Metro West Joint Development Assessment Panel Agenda

| Property Location: | No. 14 (Lots 7 & Y271) Florence Street, West Perth |
| Development Description: | Demolition of Portion of Existing Light Industry Building and Development of Fifteen Multiple Dwellings |

DAC MINUTES FROM MEETING #1 – 22 NOVEMBER 2017 AND APPLICANT RESPONSE

① WINDOW SHADE DETAIL
1 : 20

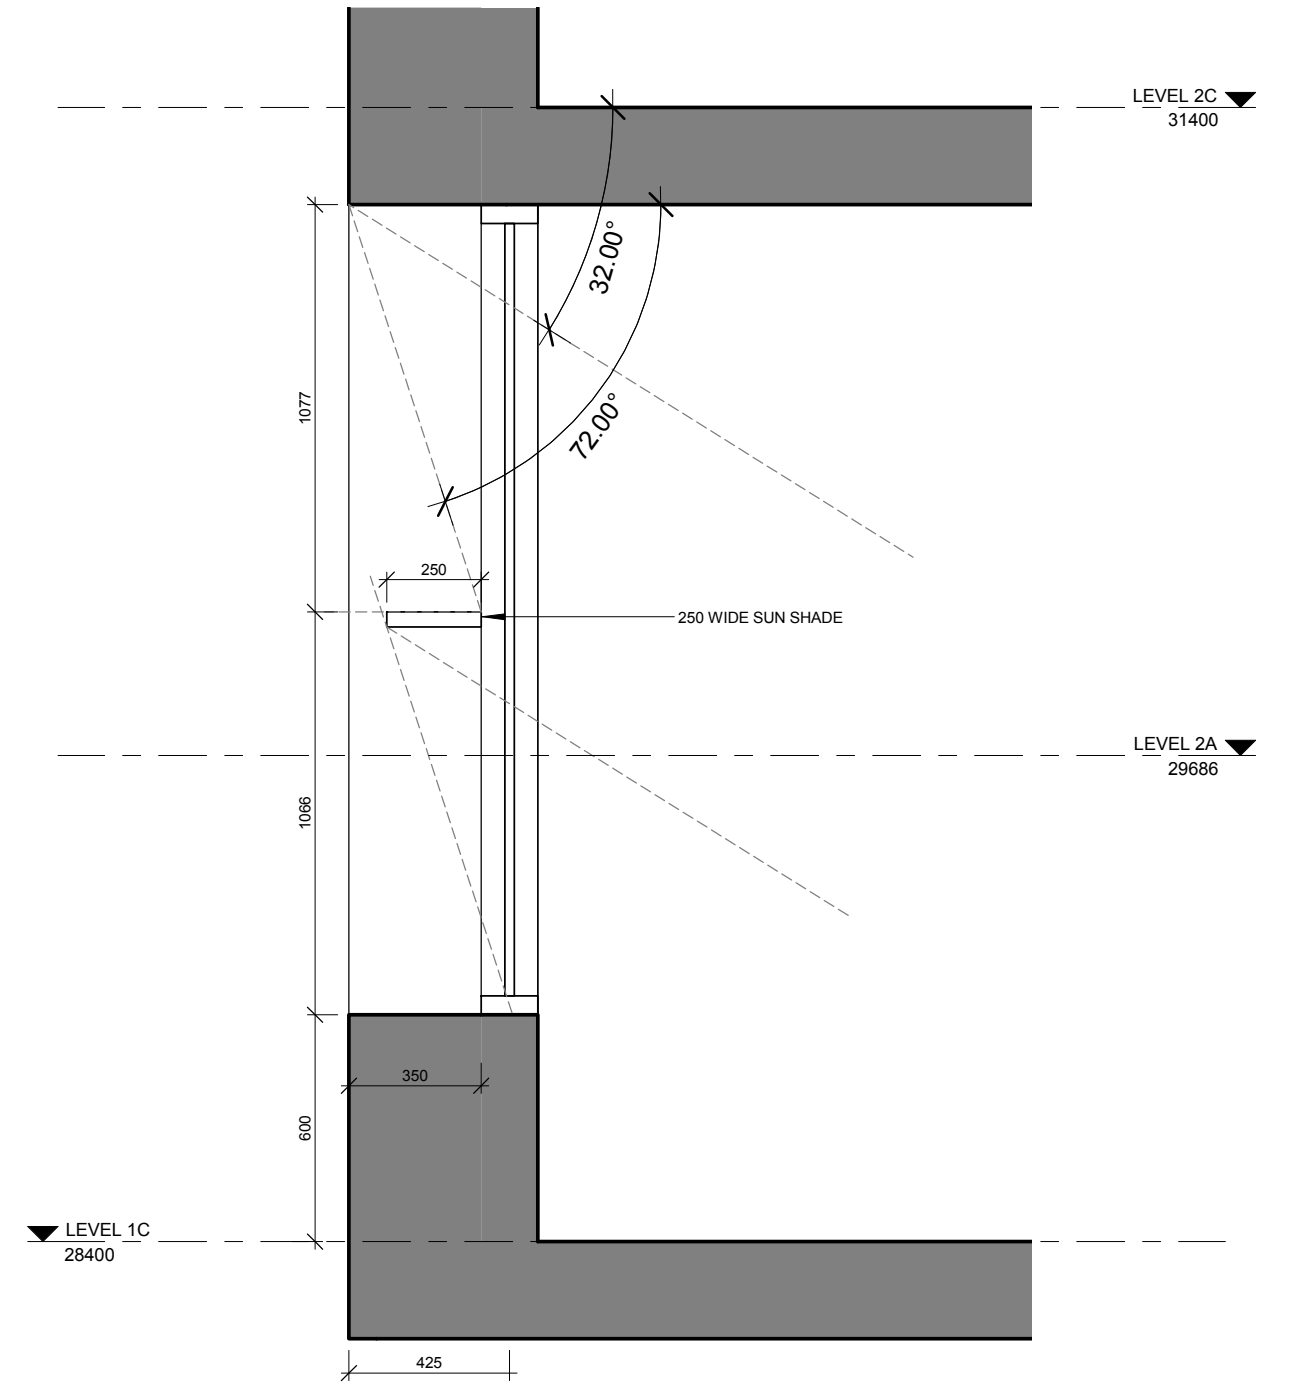
| Principle 5 – Sustainability | <ul style="list-style-type: none"> • Reconsider sun shading to the north – deeper shading is required than provided thus far, to north façade windows and treatment to west and east facades | <ul style="list-style-type: none"> • Achieved see window shade detail on DA-08 |

1 GROUND FLOOR PLOT RATIO B
1 : 500

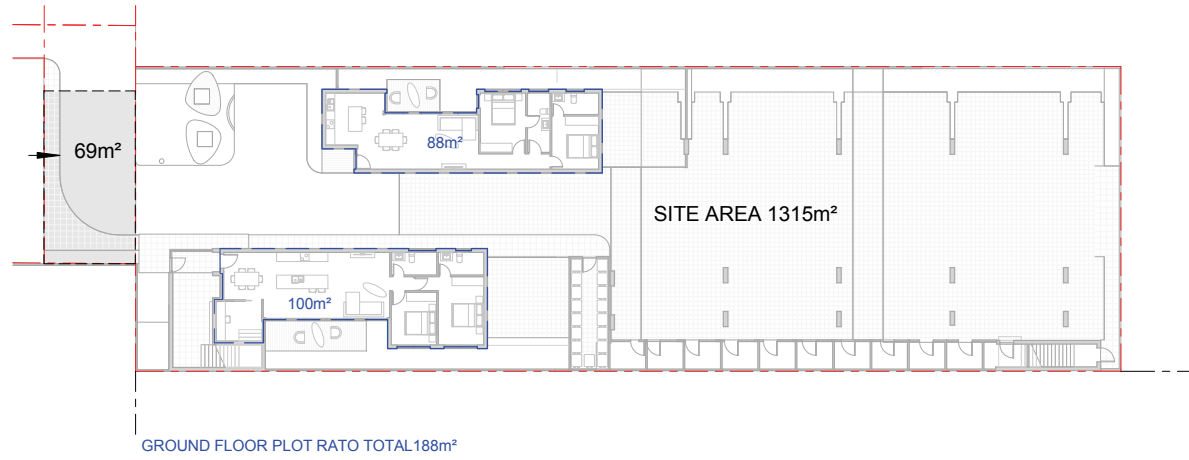
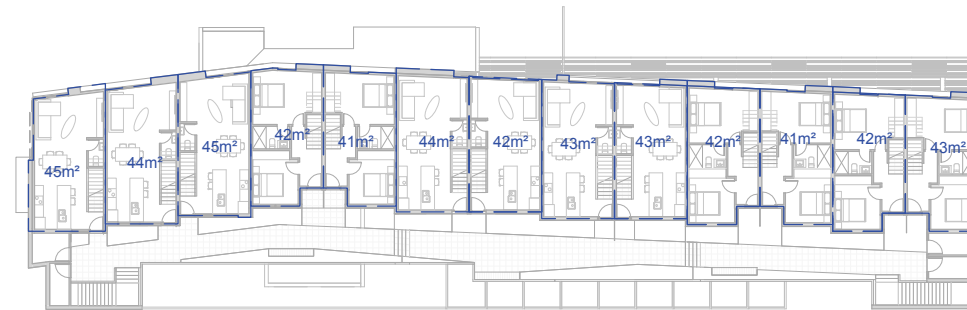
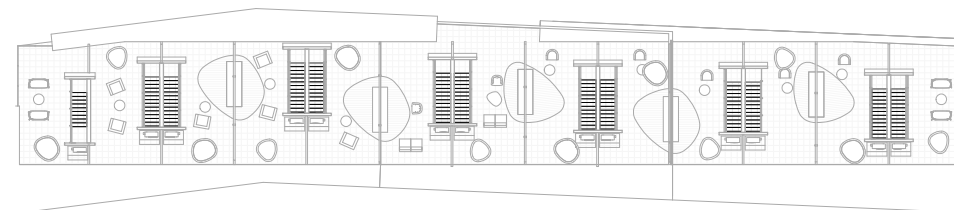
To this end we provide at **Appendix B** a more accurate plot ratio calculation, in line with Council Officers position that the stairs to the roof terrace must be included, and a more rigorous assessment of the outside walls in line with our inset windows to address design for climate responses and requests of the Design Advisory Committee.

We have also more appropriately added the area from Lot 7 that has been amalgamated into lot Y271. A portion of this land is to be used to obtain gazetted road access, with a 69m² portion to make up the front entry statement and repurposes of the roof trusses, turning area (secured through public access easements) and front accessway to the lots, please refer to **Appendix B – Calculation of Plot Ratio**. This equals a total area of 1,384m², with a plot ratio area equalling 1,442m², meaning plot ratio of 1.04.
